Certified Action of the City of Raleigh Planning Commission City of Raleigh Development Plans Review Center One Exchange Plaza Raleigh, NC 27601 (919) 996-2626 www.raleighnc.gov

Case File / Name:	SP-32-2013 / Bell View Hotel	
General Location:	The north side of Hillsborough Street between Maiden Lane and Enterprise Street	
Owner: Designer:	Bell View Partners Jones and Cnossen Engineering, PLLC	
CAC:	Wade	
Nature of Case:	A 94,389 square foot hotel containing 135 rooming units and 6,600 square feet of retail space on a .91 acre site zoned Neighborhood Business CUD, Pedestrian Business Overlay District and Special Residential Parking Overlay District. As

SUBJECT:	SP-32-13	
CROSS- REFERENCE:	Z-36-12	
LOCATION:	This site is located on the north side of Hillsborough Street between Maiden Lane and Enterprise Street inside the City Limits. It is comprised of three parcels which are currently developed.	
PIN:	0794917521, 07949184424 & 0794918535	
REQUEST:	This request is to approve a 94,389 square foot hotel containing 135 rooming units and 6,600 square feet of retail space on a .91 acre site zoned Neighborhood Business CUD, Pedestrian Business Overlay District and Special Residential Pa

SP-32-13 / Bell View Hotel – Preliminary Site Plan

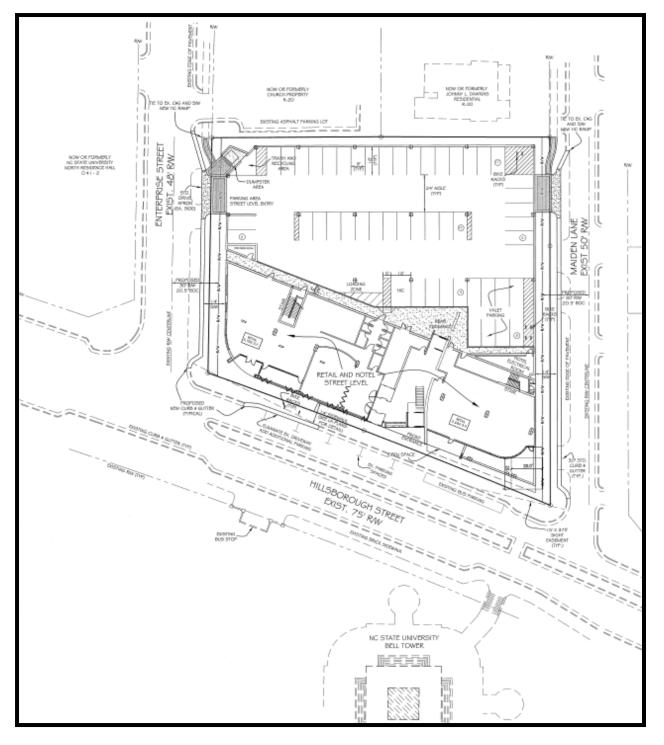
Key Issues: Requested open space alternate for reduced width sidewalks on Enterprised Street (15' length) and Maiden Lane (23' length).

(1) That as allowed by City Code Section 10-2055(d)(4), the Planning Commission finds that the alternate method of open space proposed, 5' sidewalk sections (<u>+</u>15'-23' in length) north of the proposed driveways on Enterprise Street and Maiden Lane, serve as an appropriated transition to the sidewalks located outside of the Pedestrian Business Overlay District, and the Commission finds it is in accordance with the general plans for the physical development of the City, as embodied in the Raleigh Comprehensive Plan, and the site plan meets the standards of 10-2132.2(d);
